Broyting í kravfesting til “Stórskíggi í Atrium á Glasi útboð 2019”

Amendment to requirement in “Big screen in Atrium at Glasir tender 2019”

Figure 1 – Mynd av stórskíggja í KVF / Picture of big screen in KVF (kelda/source: kvf.fo)

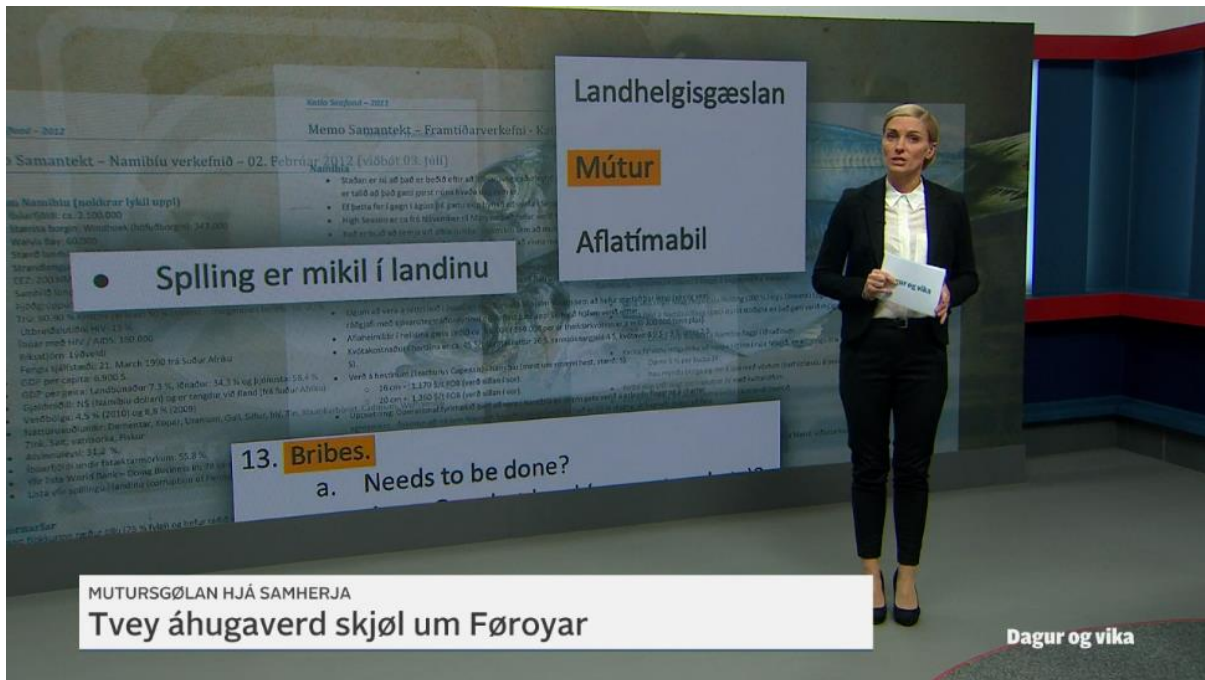
Vit vóru somikið væl nøgdir við skermin, at vit hava valt at slaka okkara krav um “pixel pitch” frá 1,27 mm til **2,6 mm**.

We were so pleased with the screen that we have decided to slacken our requirement of a pixel pitch of 1.27 mm to **2.6 mm**.

Sostatt er krafestingin til “pixel pitch” hereftir hægst 2,6 mm.

Consequently, our requirement of pixel pitch is henceforth a maximum of 2.6 mm.
